2. The object of this test was to determine how closely the motor-driven siren complied with the specifications, reference (b), and its suitability for use in the Naval Service.

4. This siren, known as Navy Type Q, was manufactured and submitted for test by the E. D. Bullard Company, San Francisco, California, for application on Contract NOS-39868.

12. Further details of the design and construction are shown on plates 1 and 2.

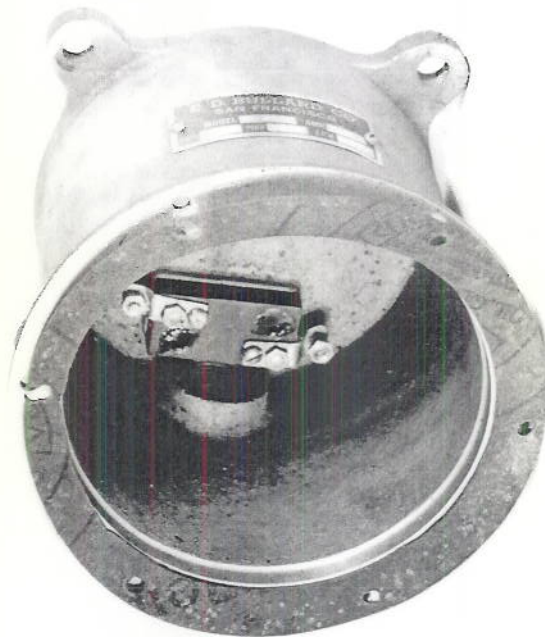
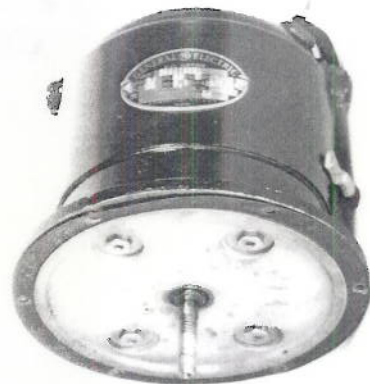
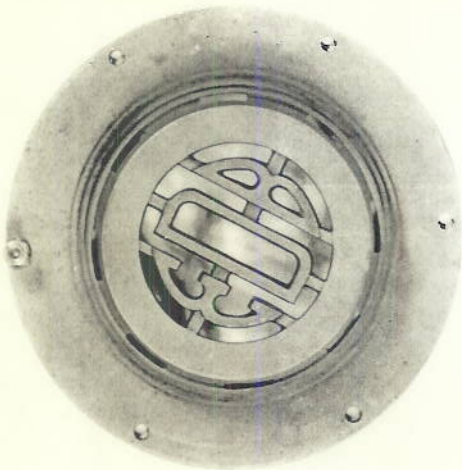
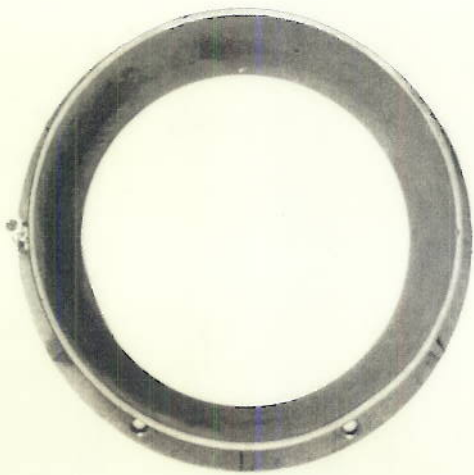
21. The siren, under test for watertight integrity, leaked 10 c.c. of water. This defect can be corrected by using a thicker "Vellumoid" gasket between the case and rotor housing.

23. The present terminal lugs do not comply with specification D-15 of reference (b).

24. Tapped holes for securing the nameplate should not extend through the case. Steel screws, cadmium plated, should be substituted for the brass screws.

25. All faying surfaces between aluminum parts should be treated with a bituminous paint prior to assembly.

26. The Bureau's attention is invited to the fact that the case does not embody a connection box. To make line connections it is necessary to remove the motor from the case.

29. Brass parts of the motor grease cups are in contact with aluminum; steel, cadmium plated, should be substituted.

30. Steel liners, cadmium plated, force fit, should be inserted in the aluminum motor end bells to prevent contact between them and the bronze bearings. This should reduce the electrolytic action between the dissimilar metals.
